Subject: Amended Report of Waste Discharge, Big Oak Flat (Groveland) Landfill,
Tuolumne County, California

This letter was prepared on behalf of the Tuolumne County Community Resources Agency to provide comments on the Central Valley Regional Water Quality Control Board (RWQCB) Administrative Draft Waste Discharge Requirements (AD WDRs) and related documents for the Tuolumne County Groveland Landfill. The AD WDRs contain a number of findings and include several new requirements based on these findings. Our review indicates that most of the information in the AD WDRs was taken from previously submitted site documents and from the existing WDRs for the landfill. Principal comments on the AD WDRs and related AD Information Sheet and Monitoring and Reporting Program are summarized below.

GMW-3 AND GMW-2 BORING AND WELL COMPLETION INFORMATION

FIGURE 1

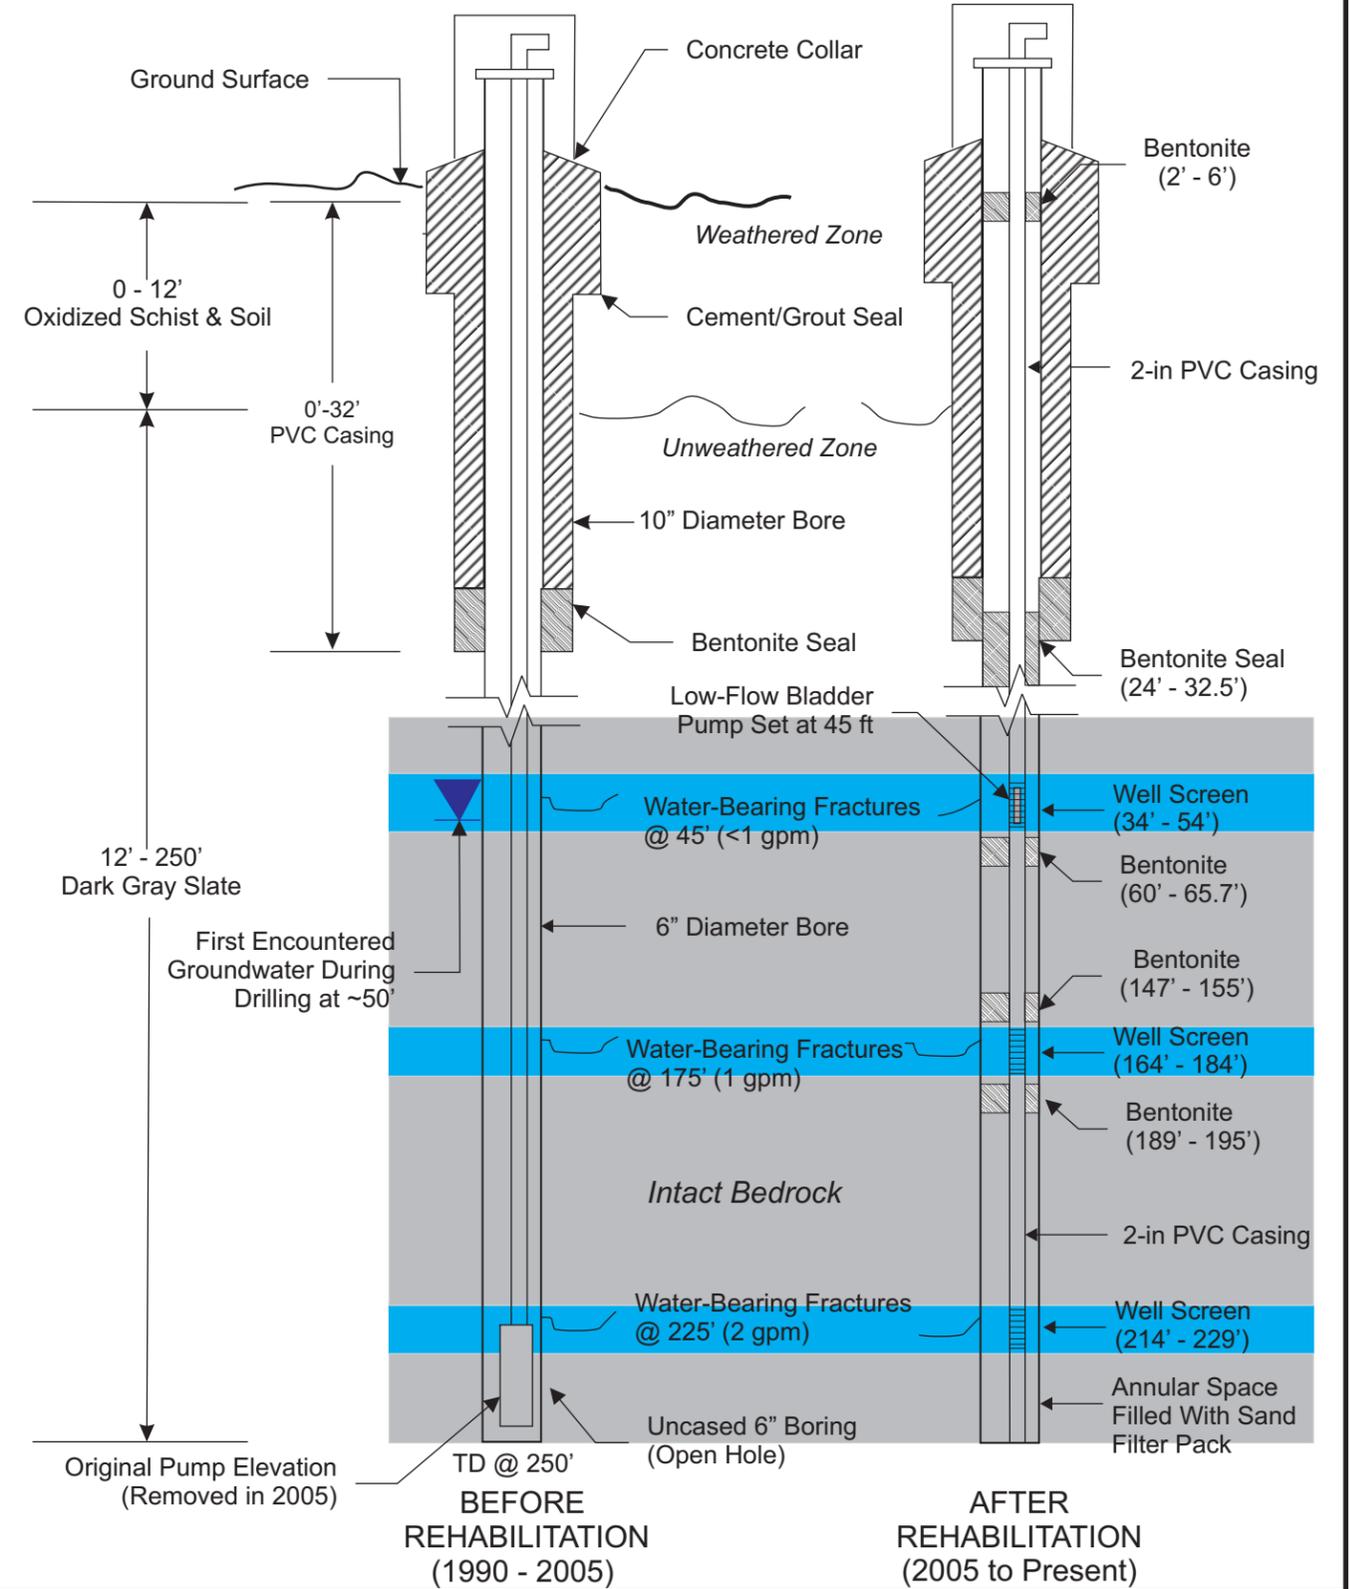
This statement is factually incorrect; to the best of our knowledge no monitoring report ever indirectly or directly related the improvements in groundwater quality at the site to the rehabilitation work on wells GMW-2 and GMW-3. This is because site data show a significant improvement in groundwater quality in GMW-2 before closure of the landfill in 2003 and before rehabilitation of the wells in 2005. Moreover, as described in more detail below and shown in Figure 1, wells GMW-2 and GMW-3 monitor the same fracture zones both before and after well rehabilitation.

³The AD Information Sheet also states that the Discharger changed the well screen locations as part of the rehabilitation work. This also is not correct. Well screens were not present within the water-bearing zone in either well prior to rehabilitation. Following rehabilitation, well screens were placed opposite the water-bearing fractures. However, it is important to understand that the screened intervals monitor the same open borehole intervals that were monitored before the rehabilitation work.
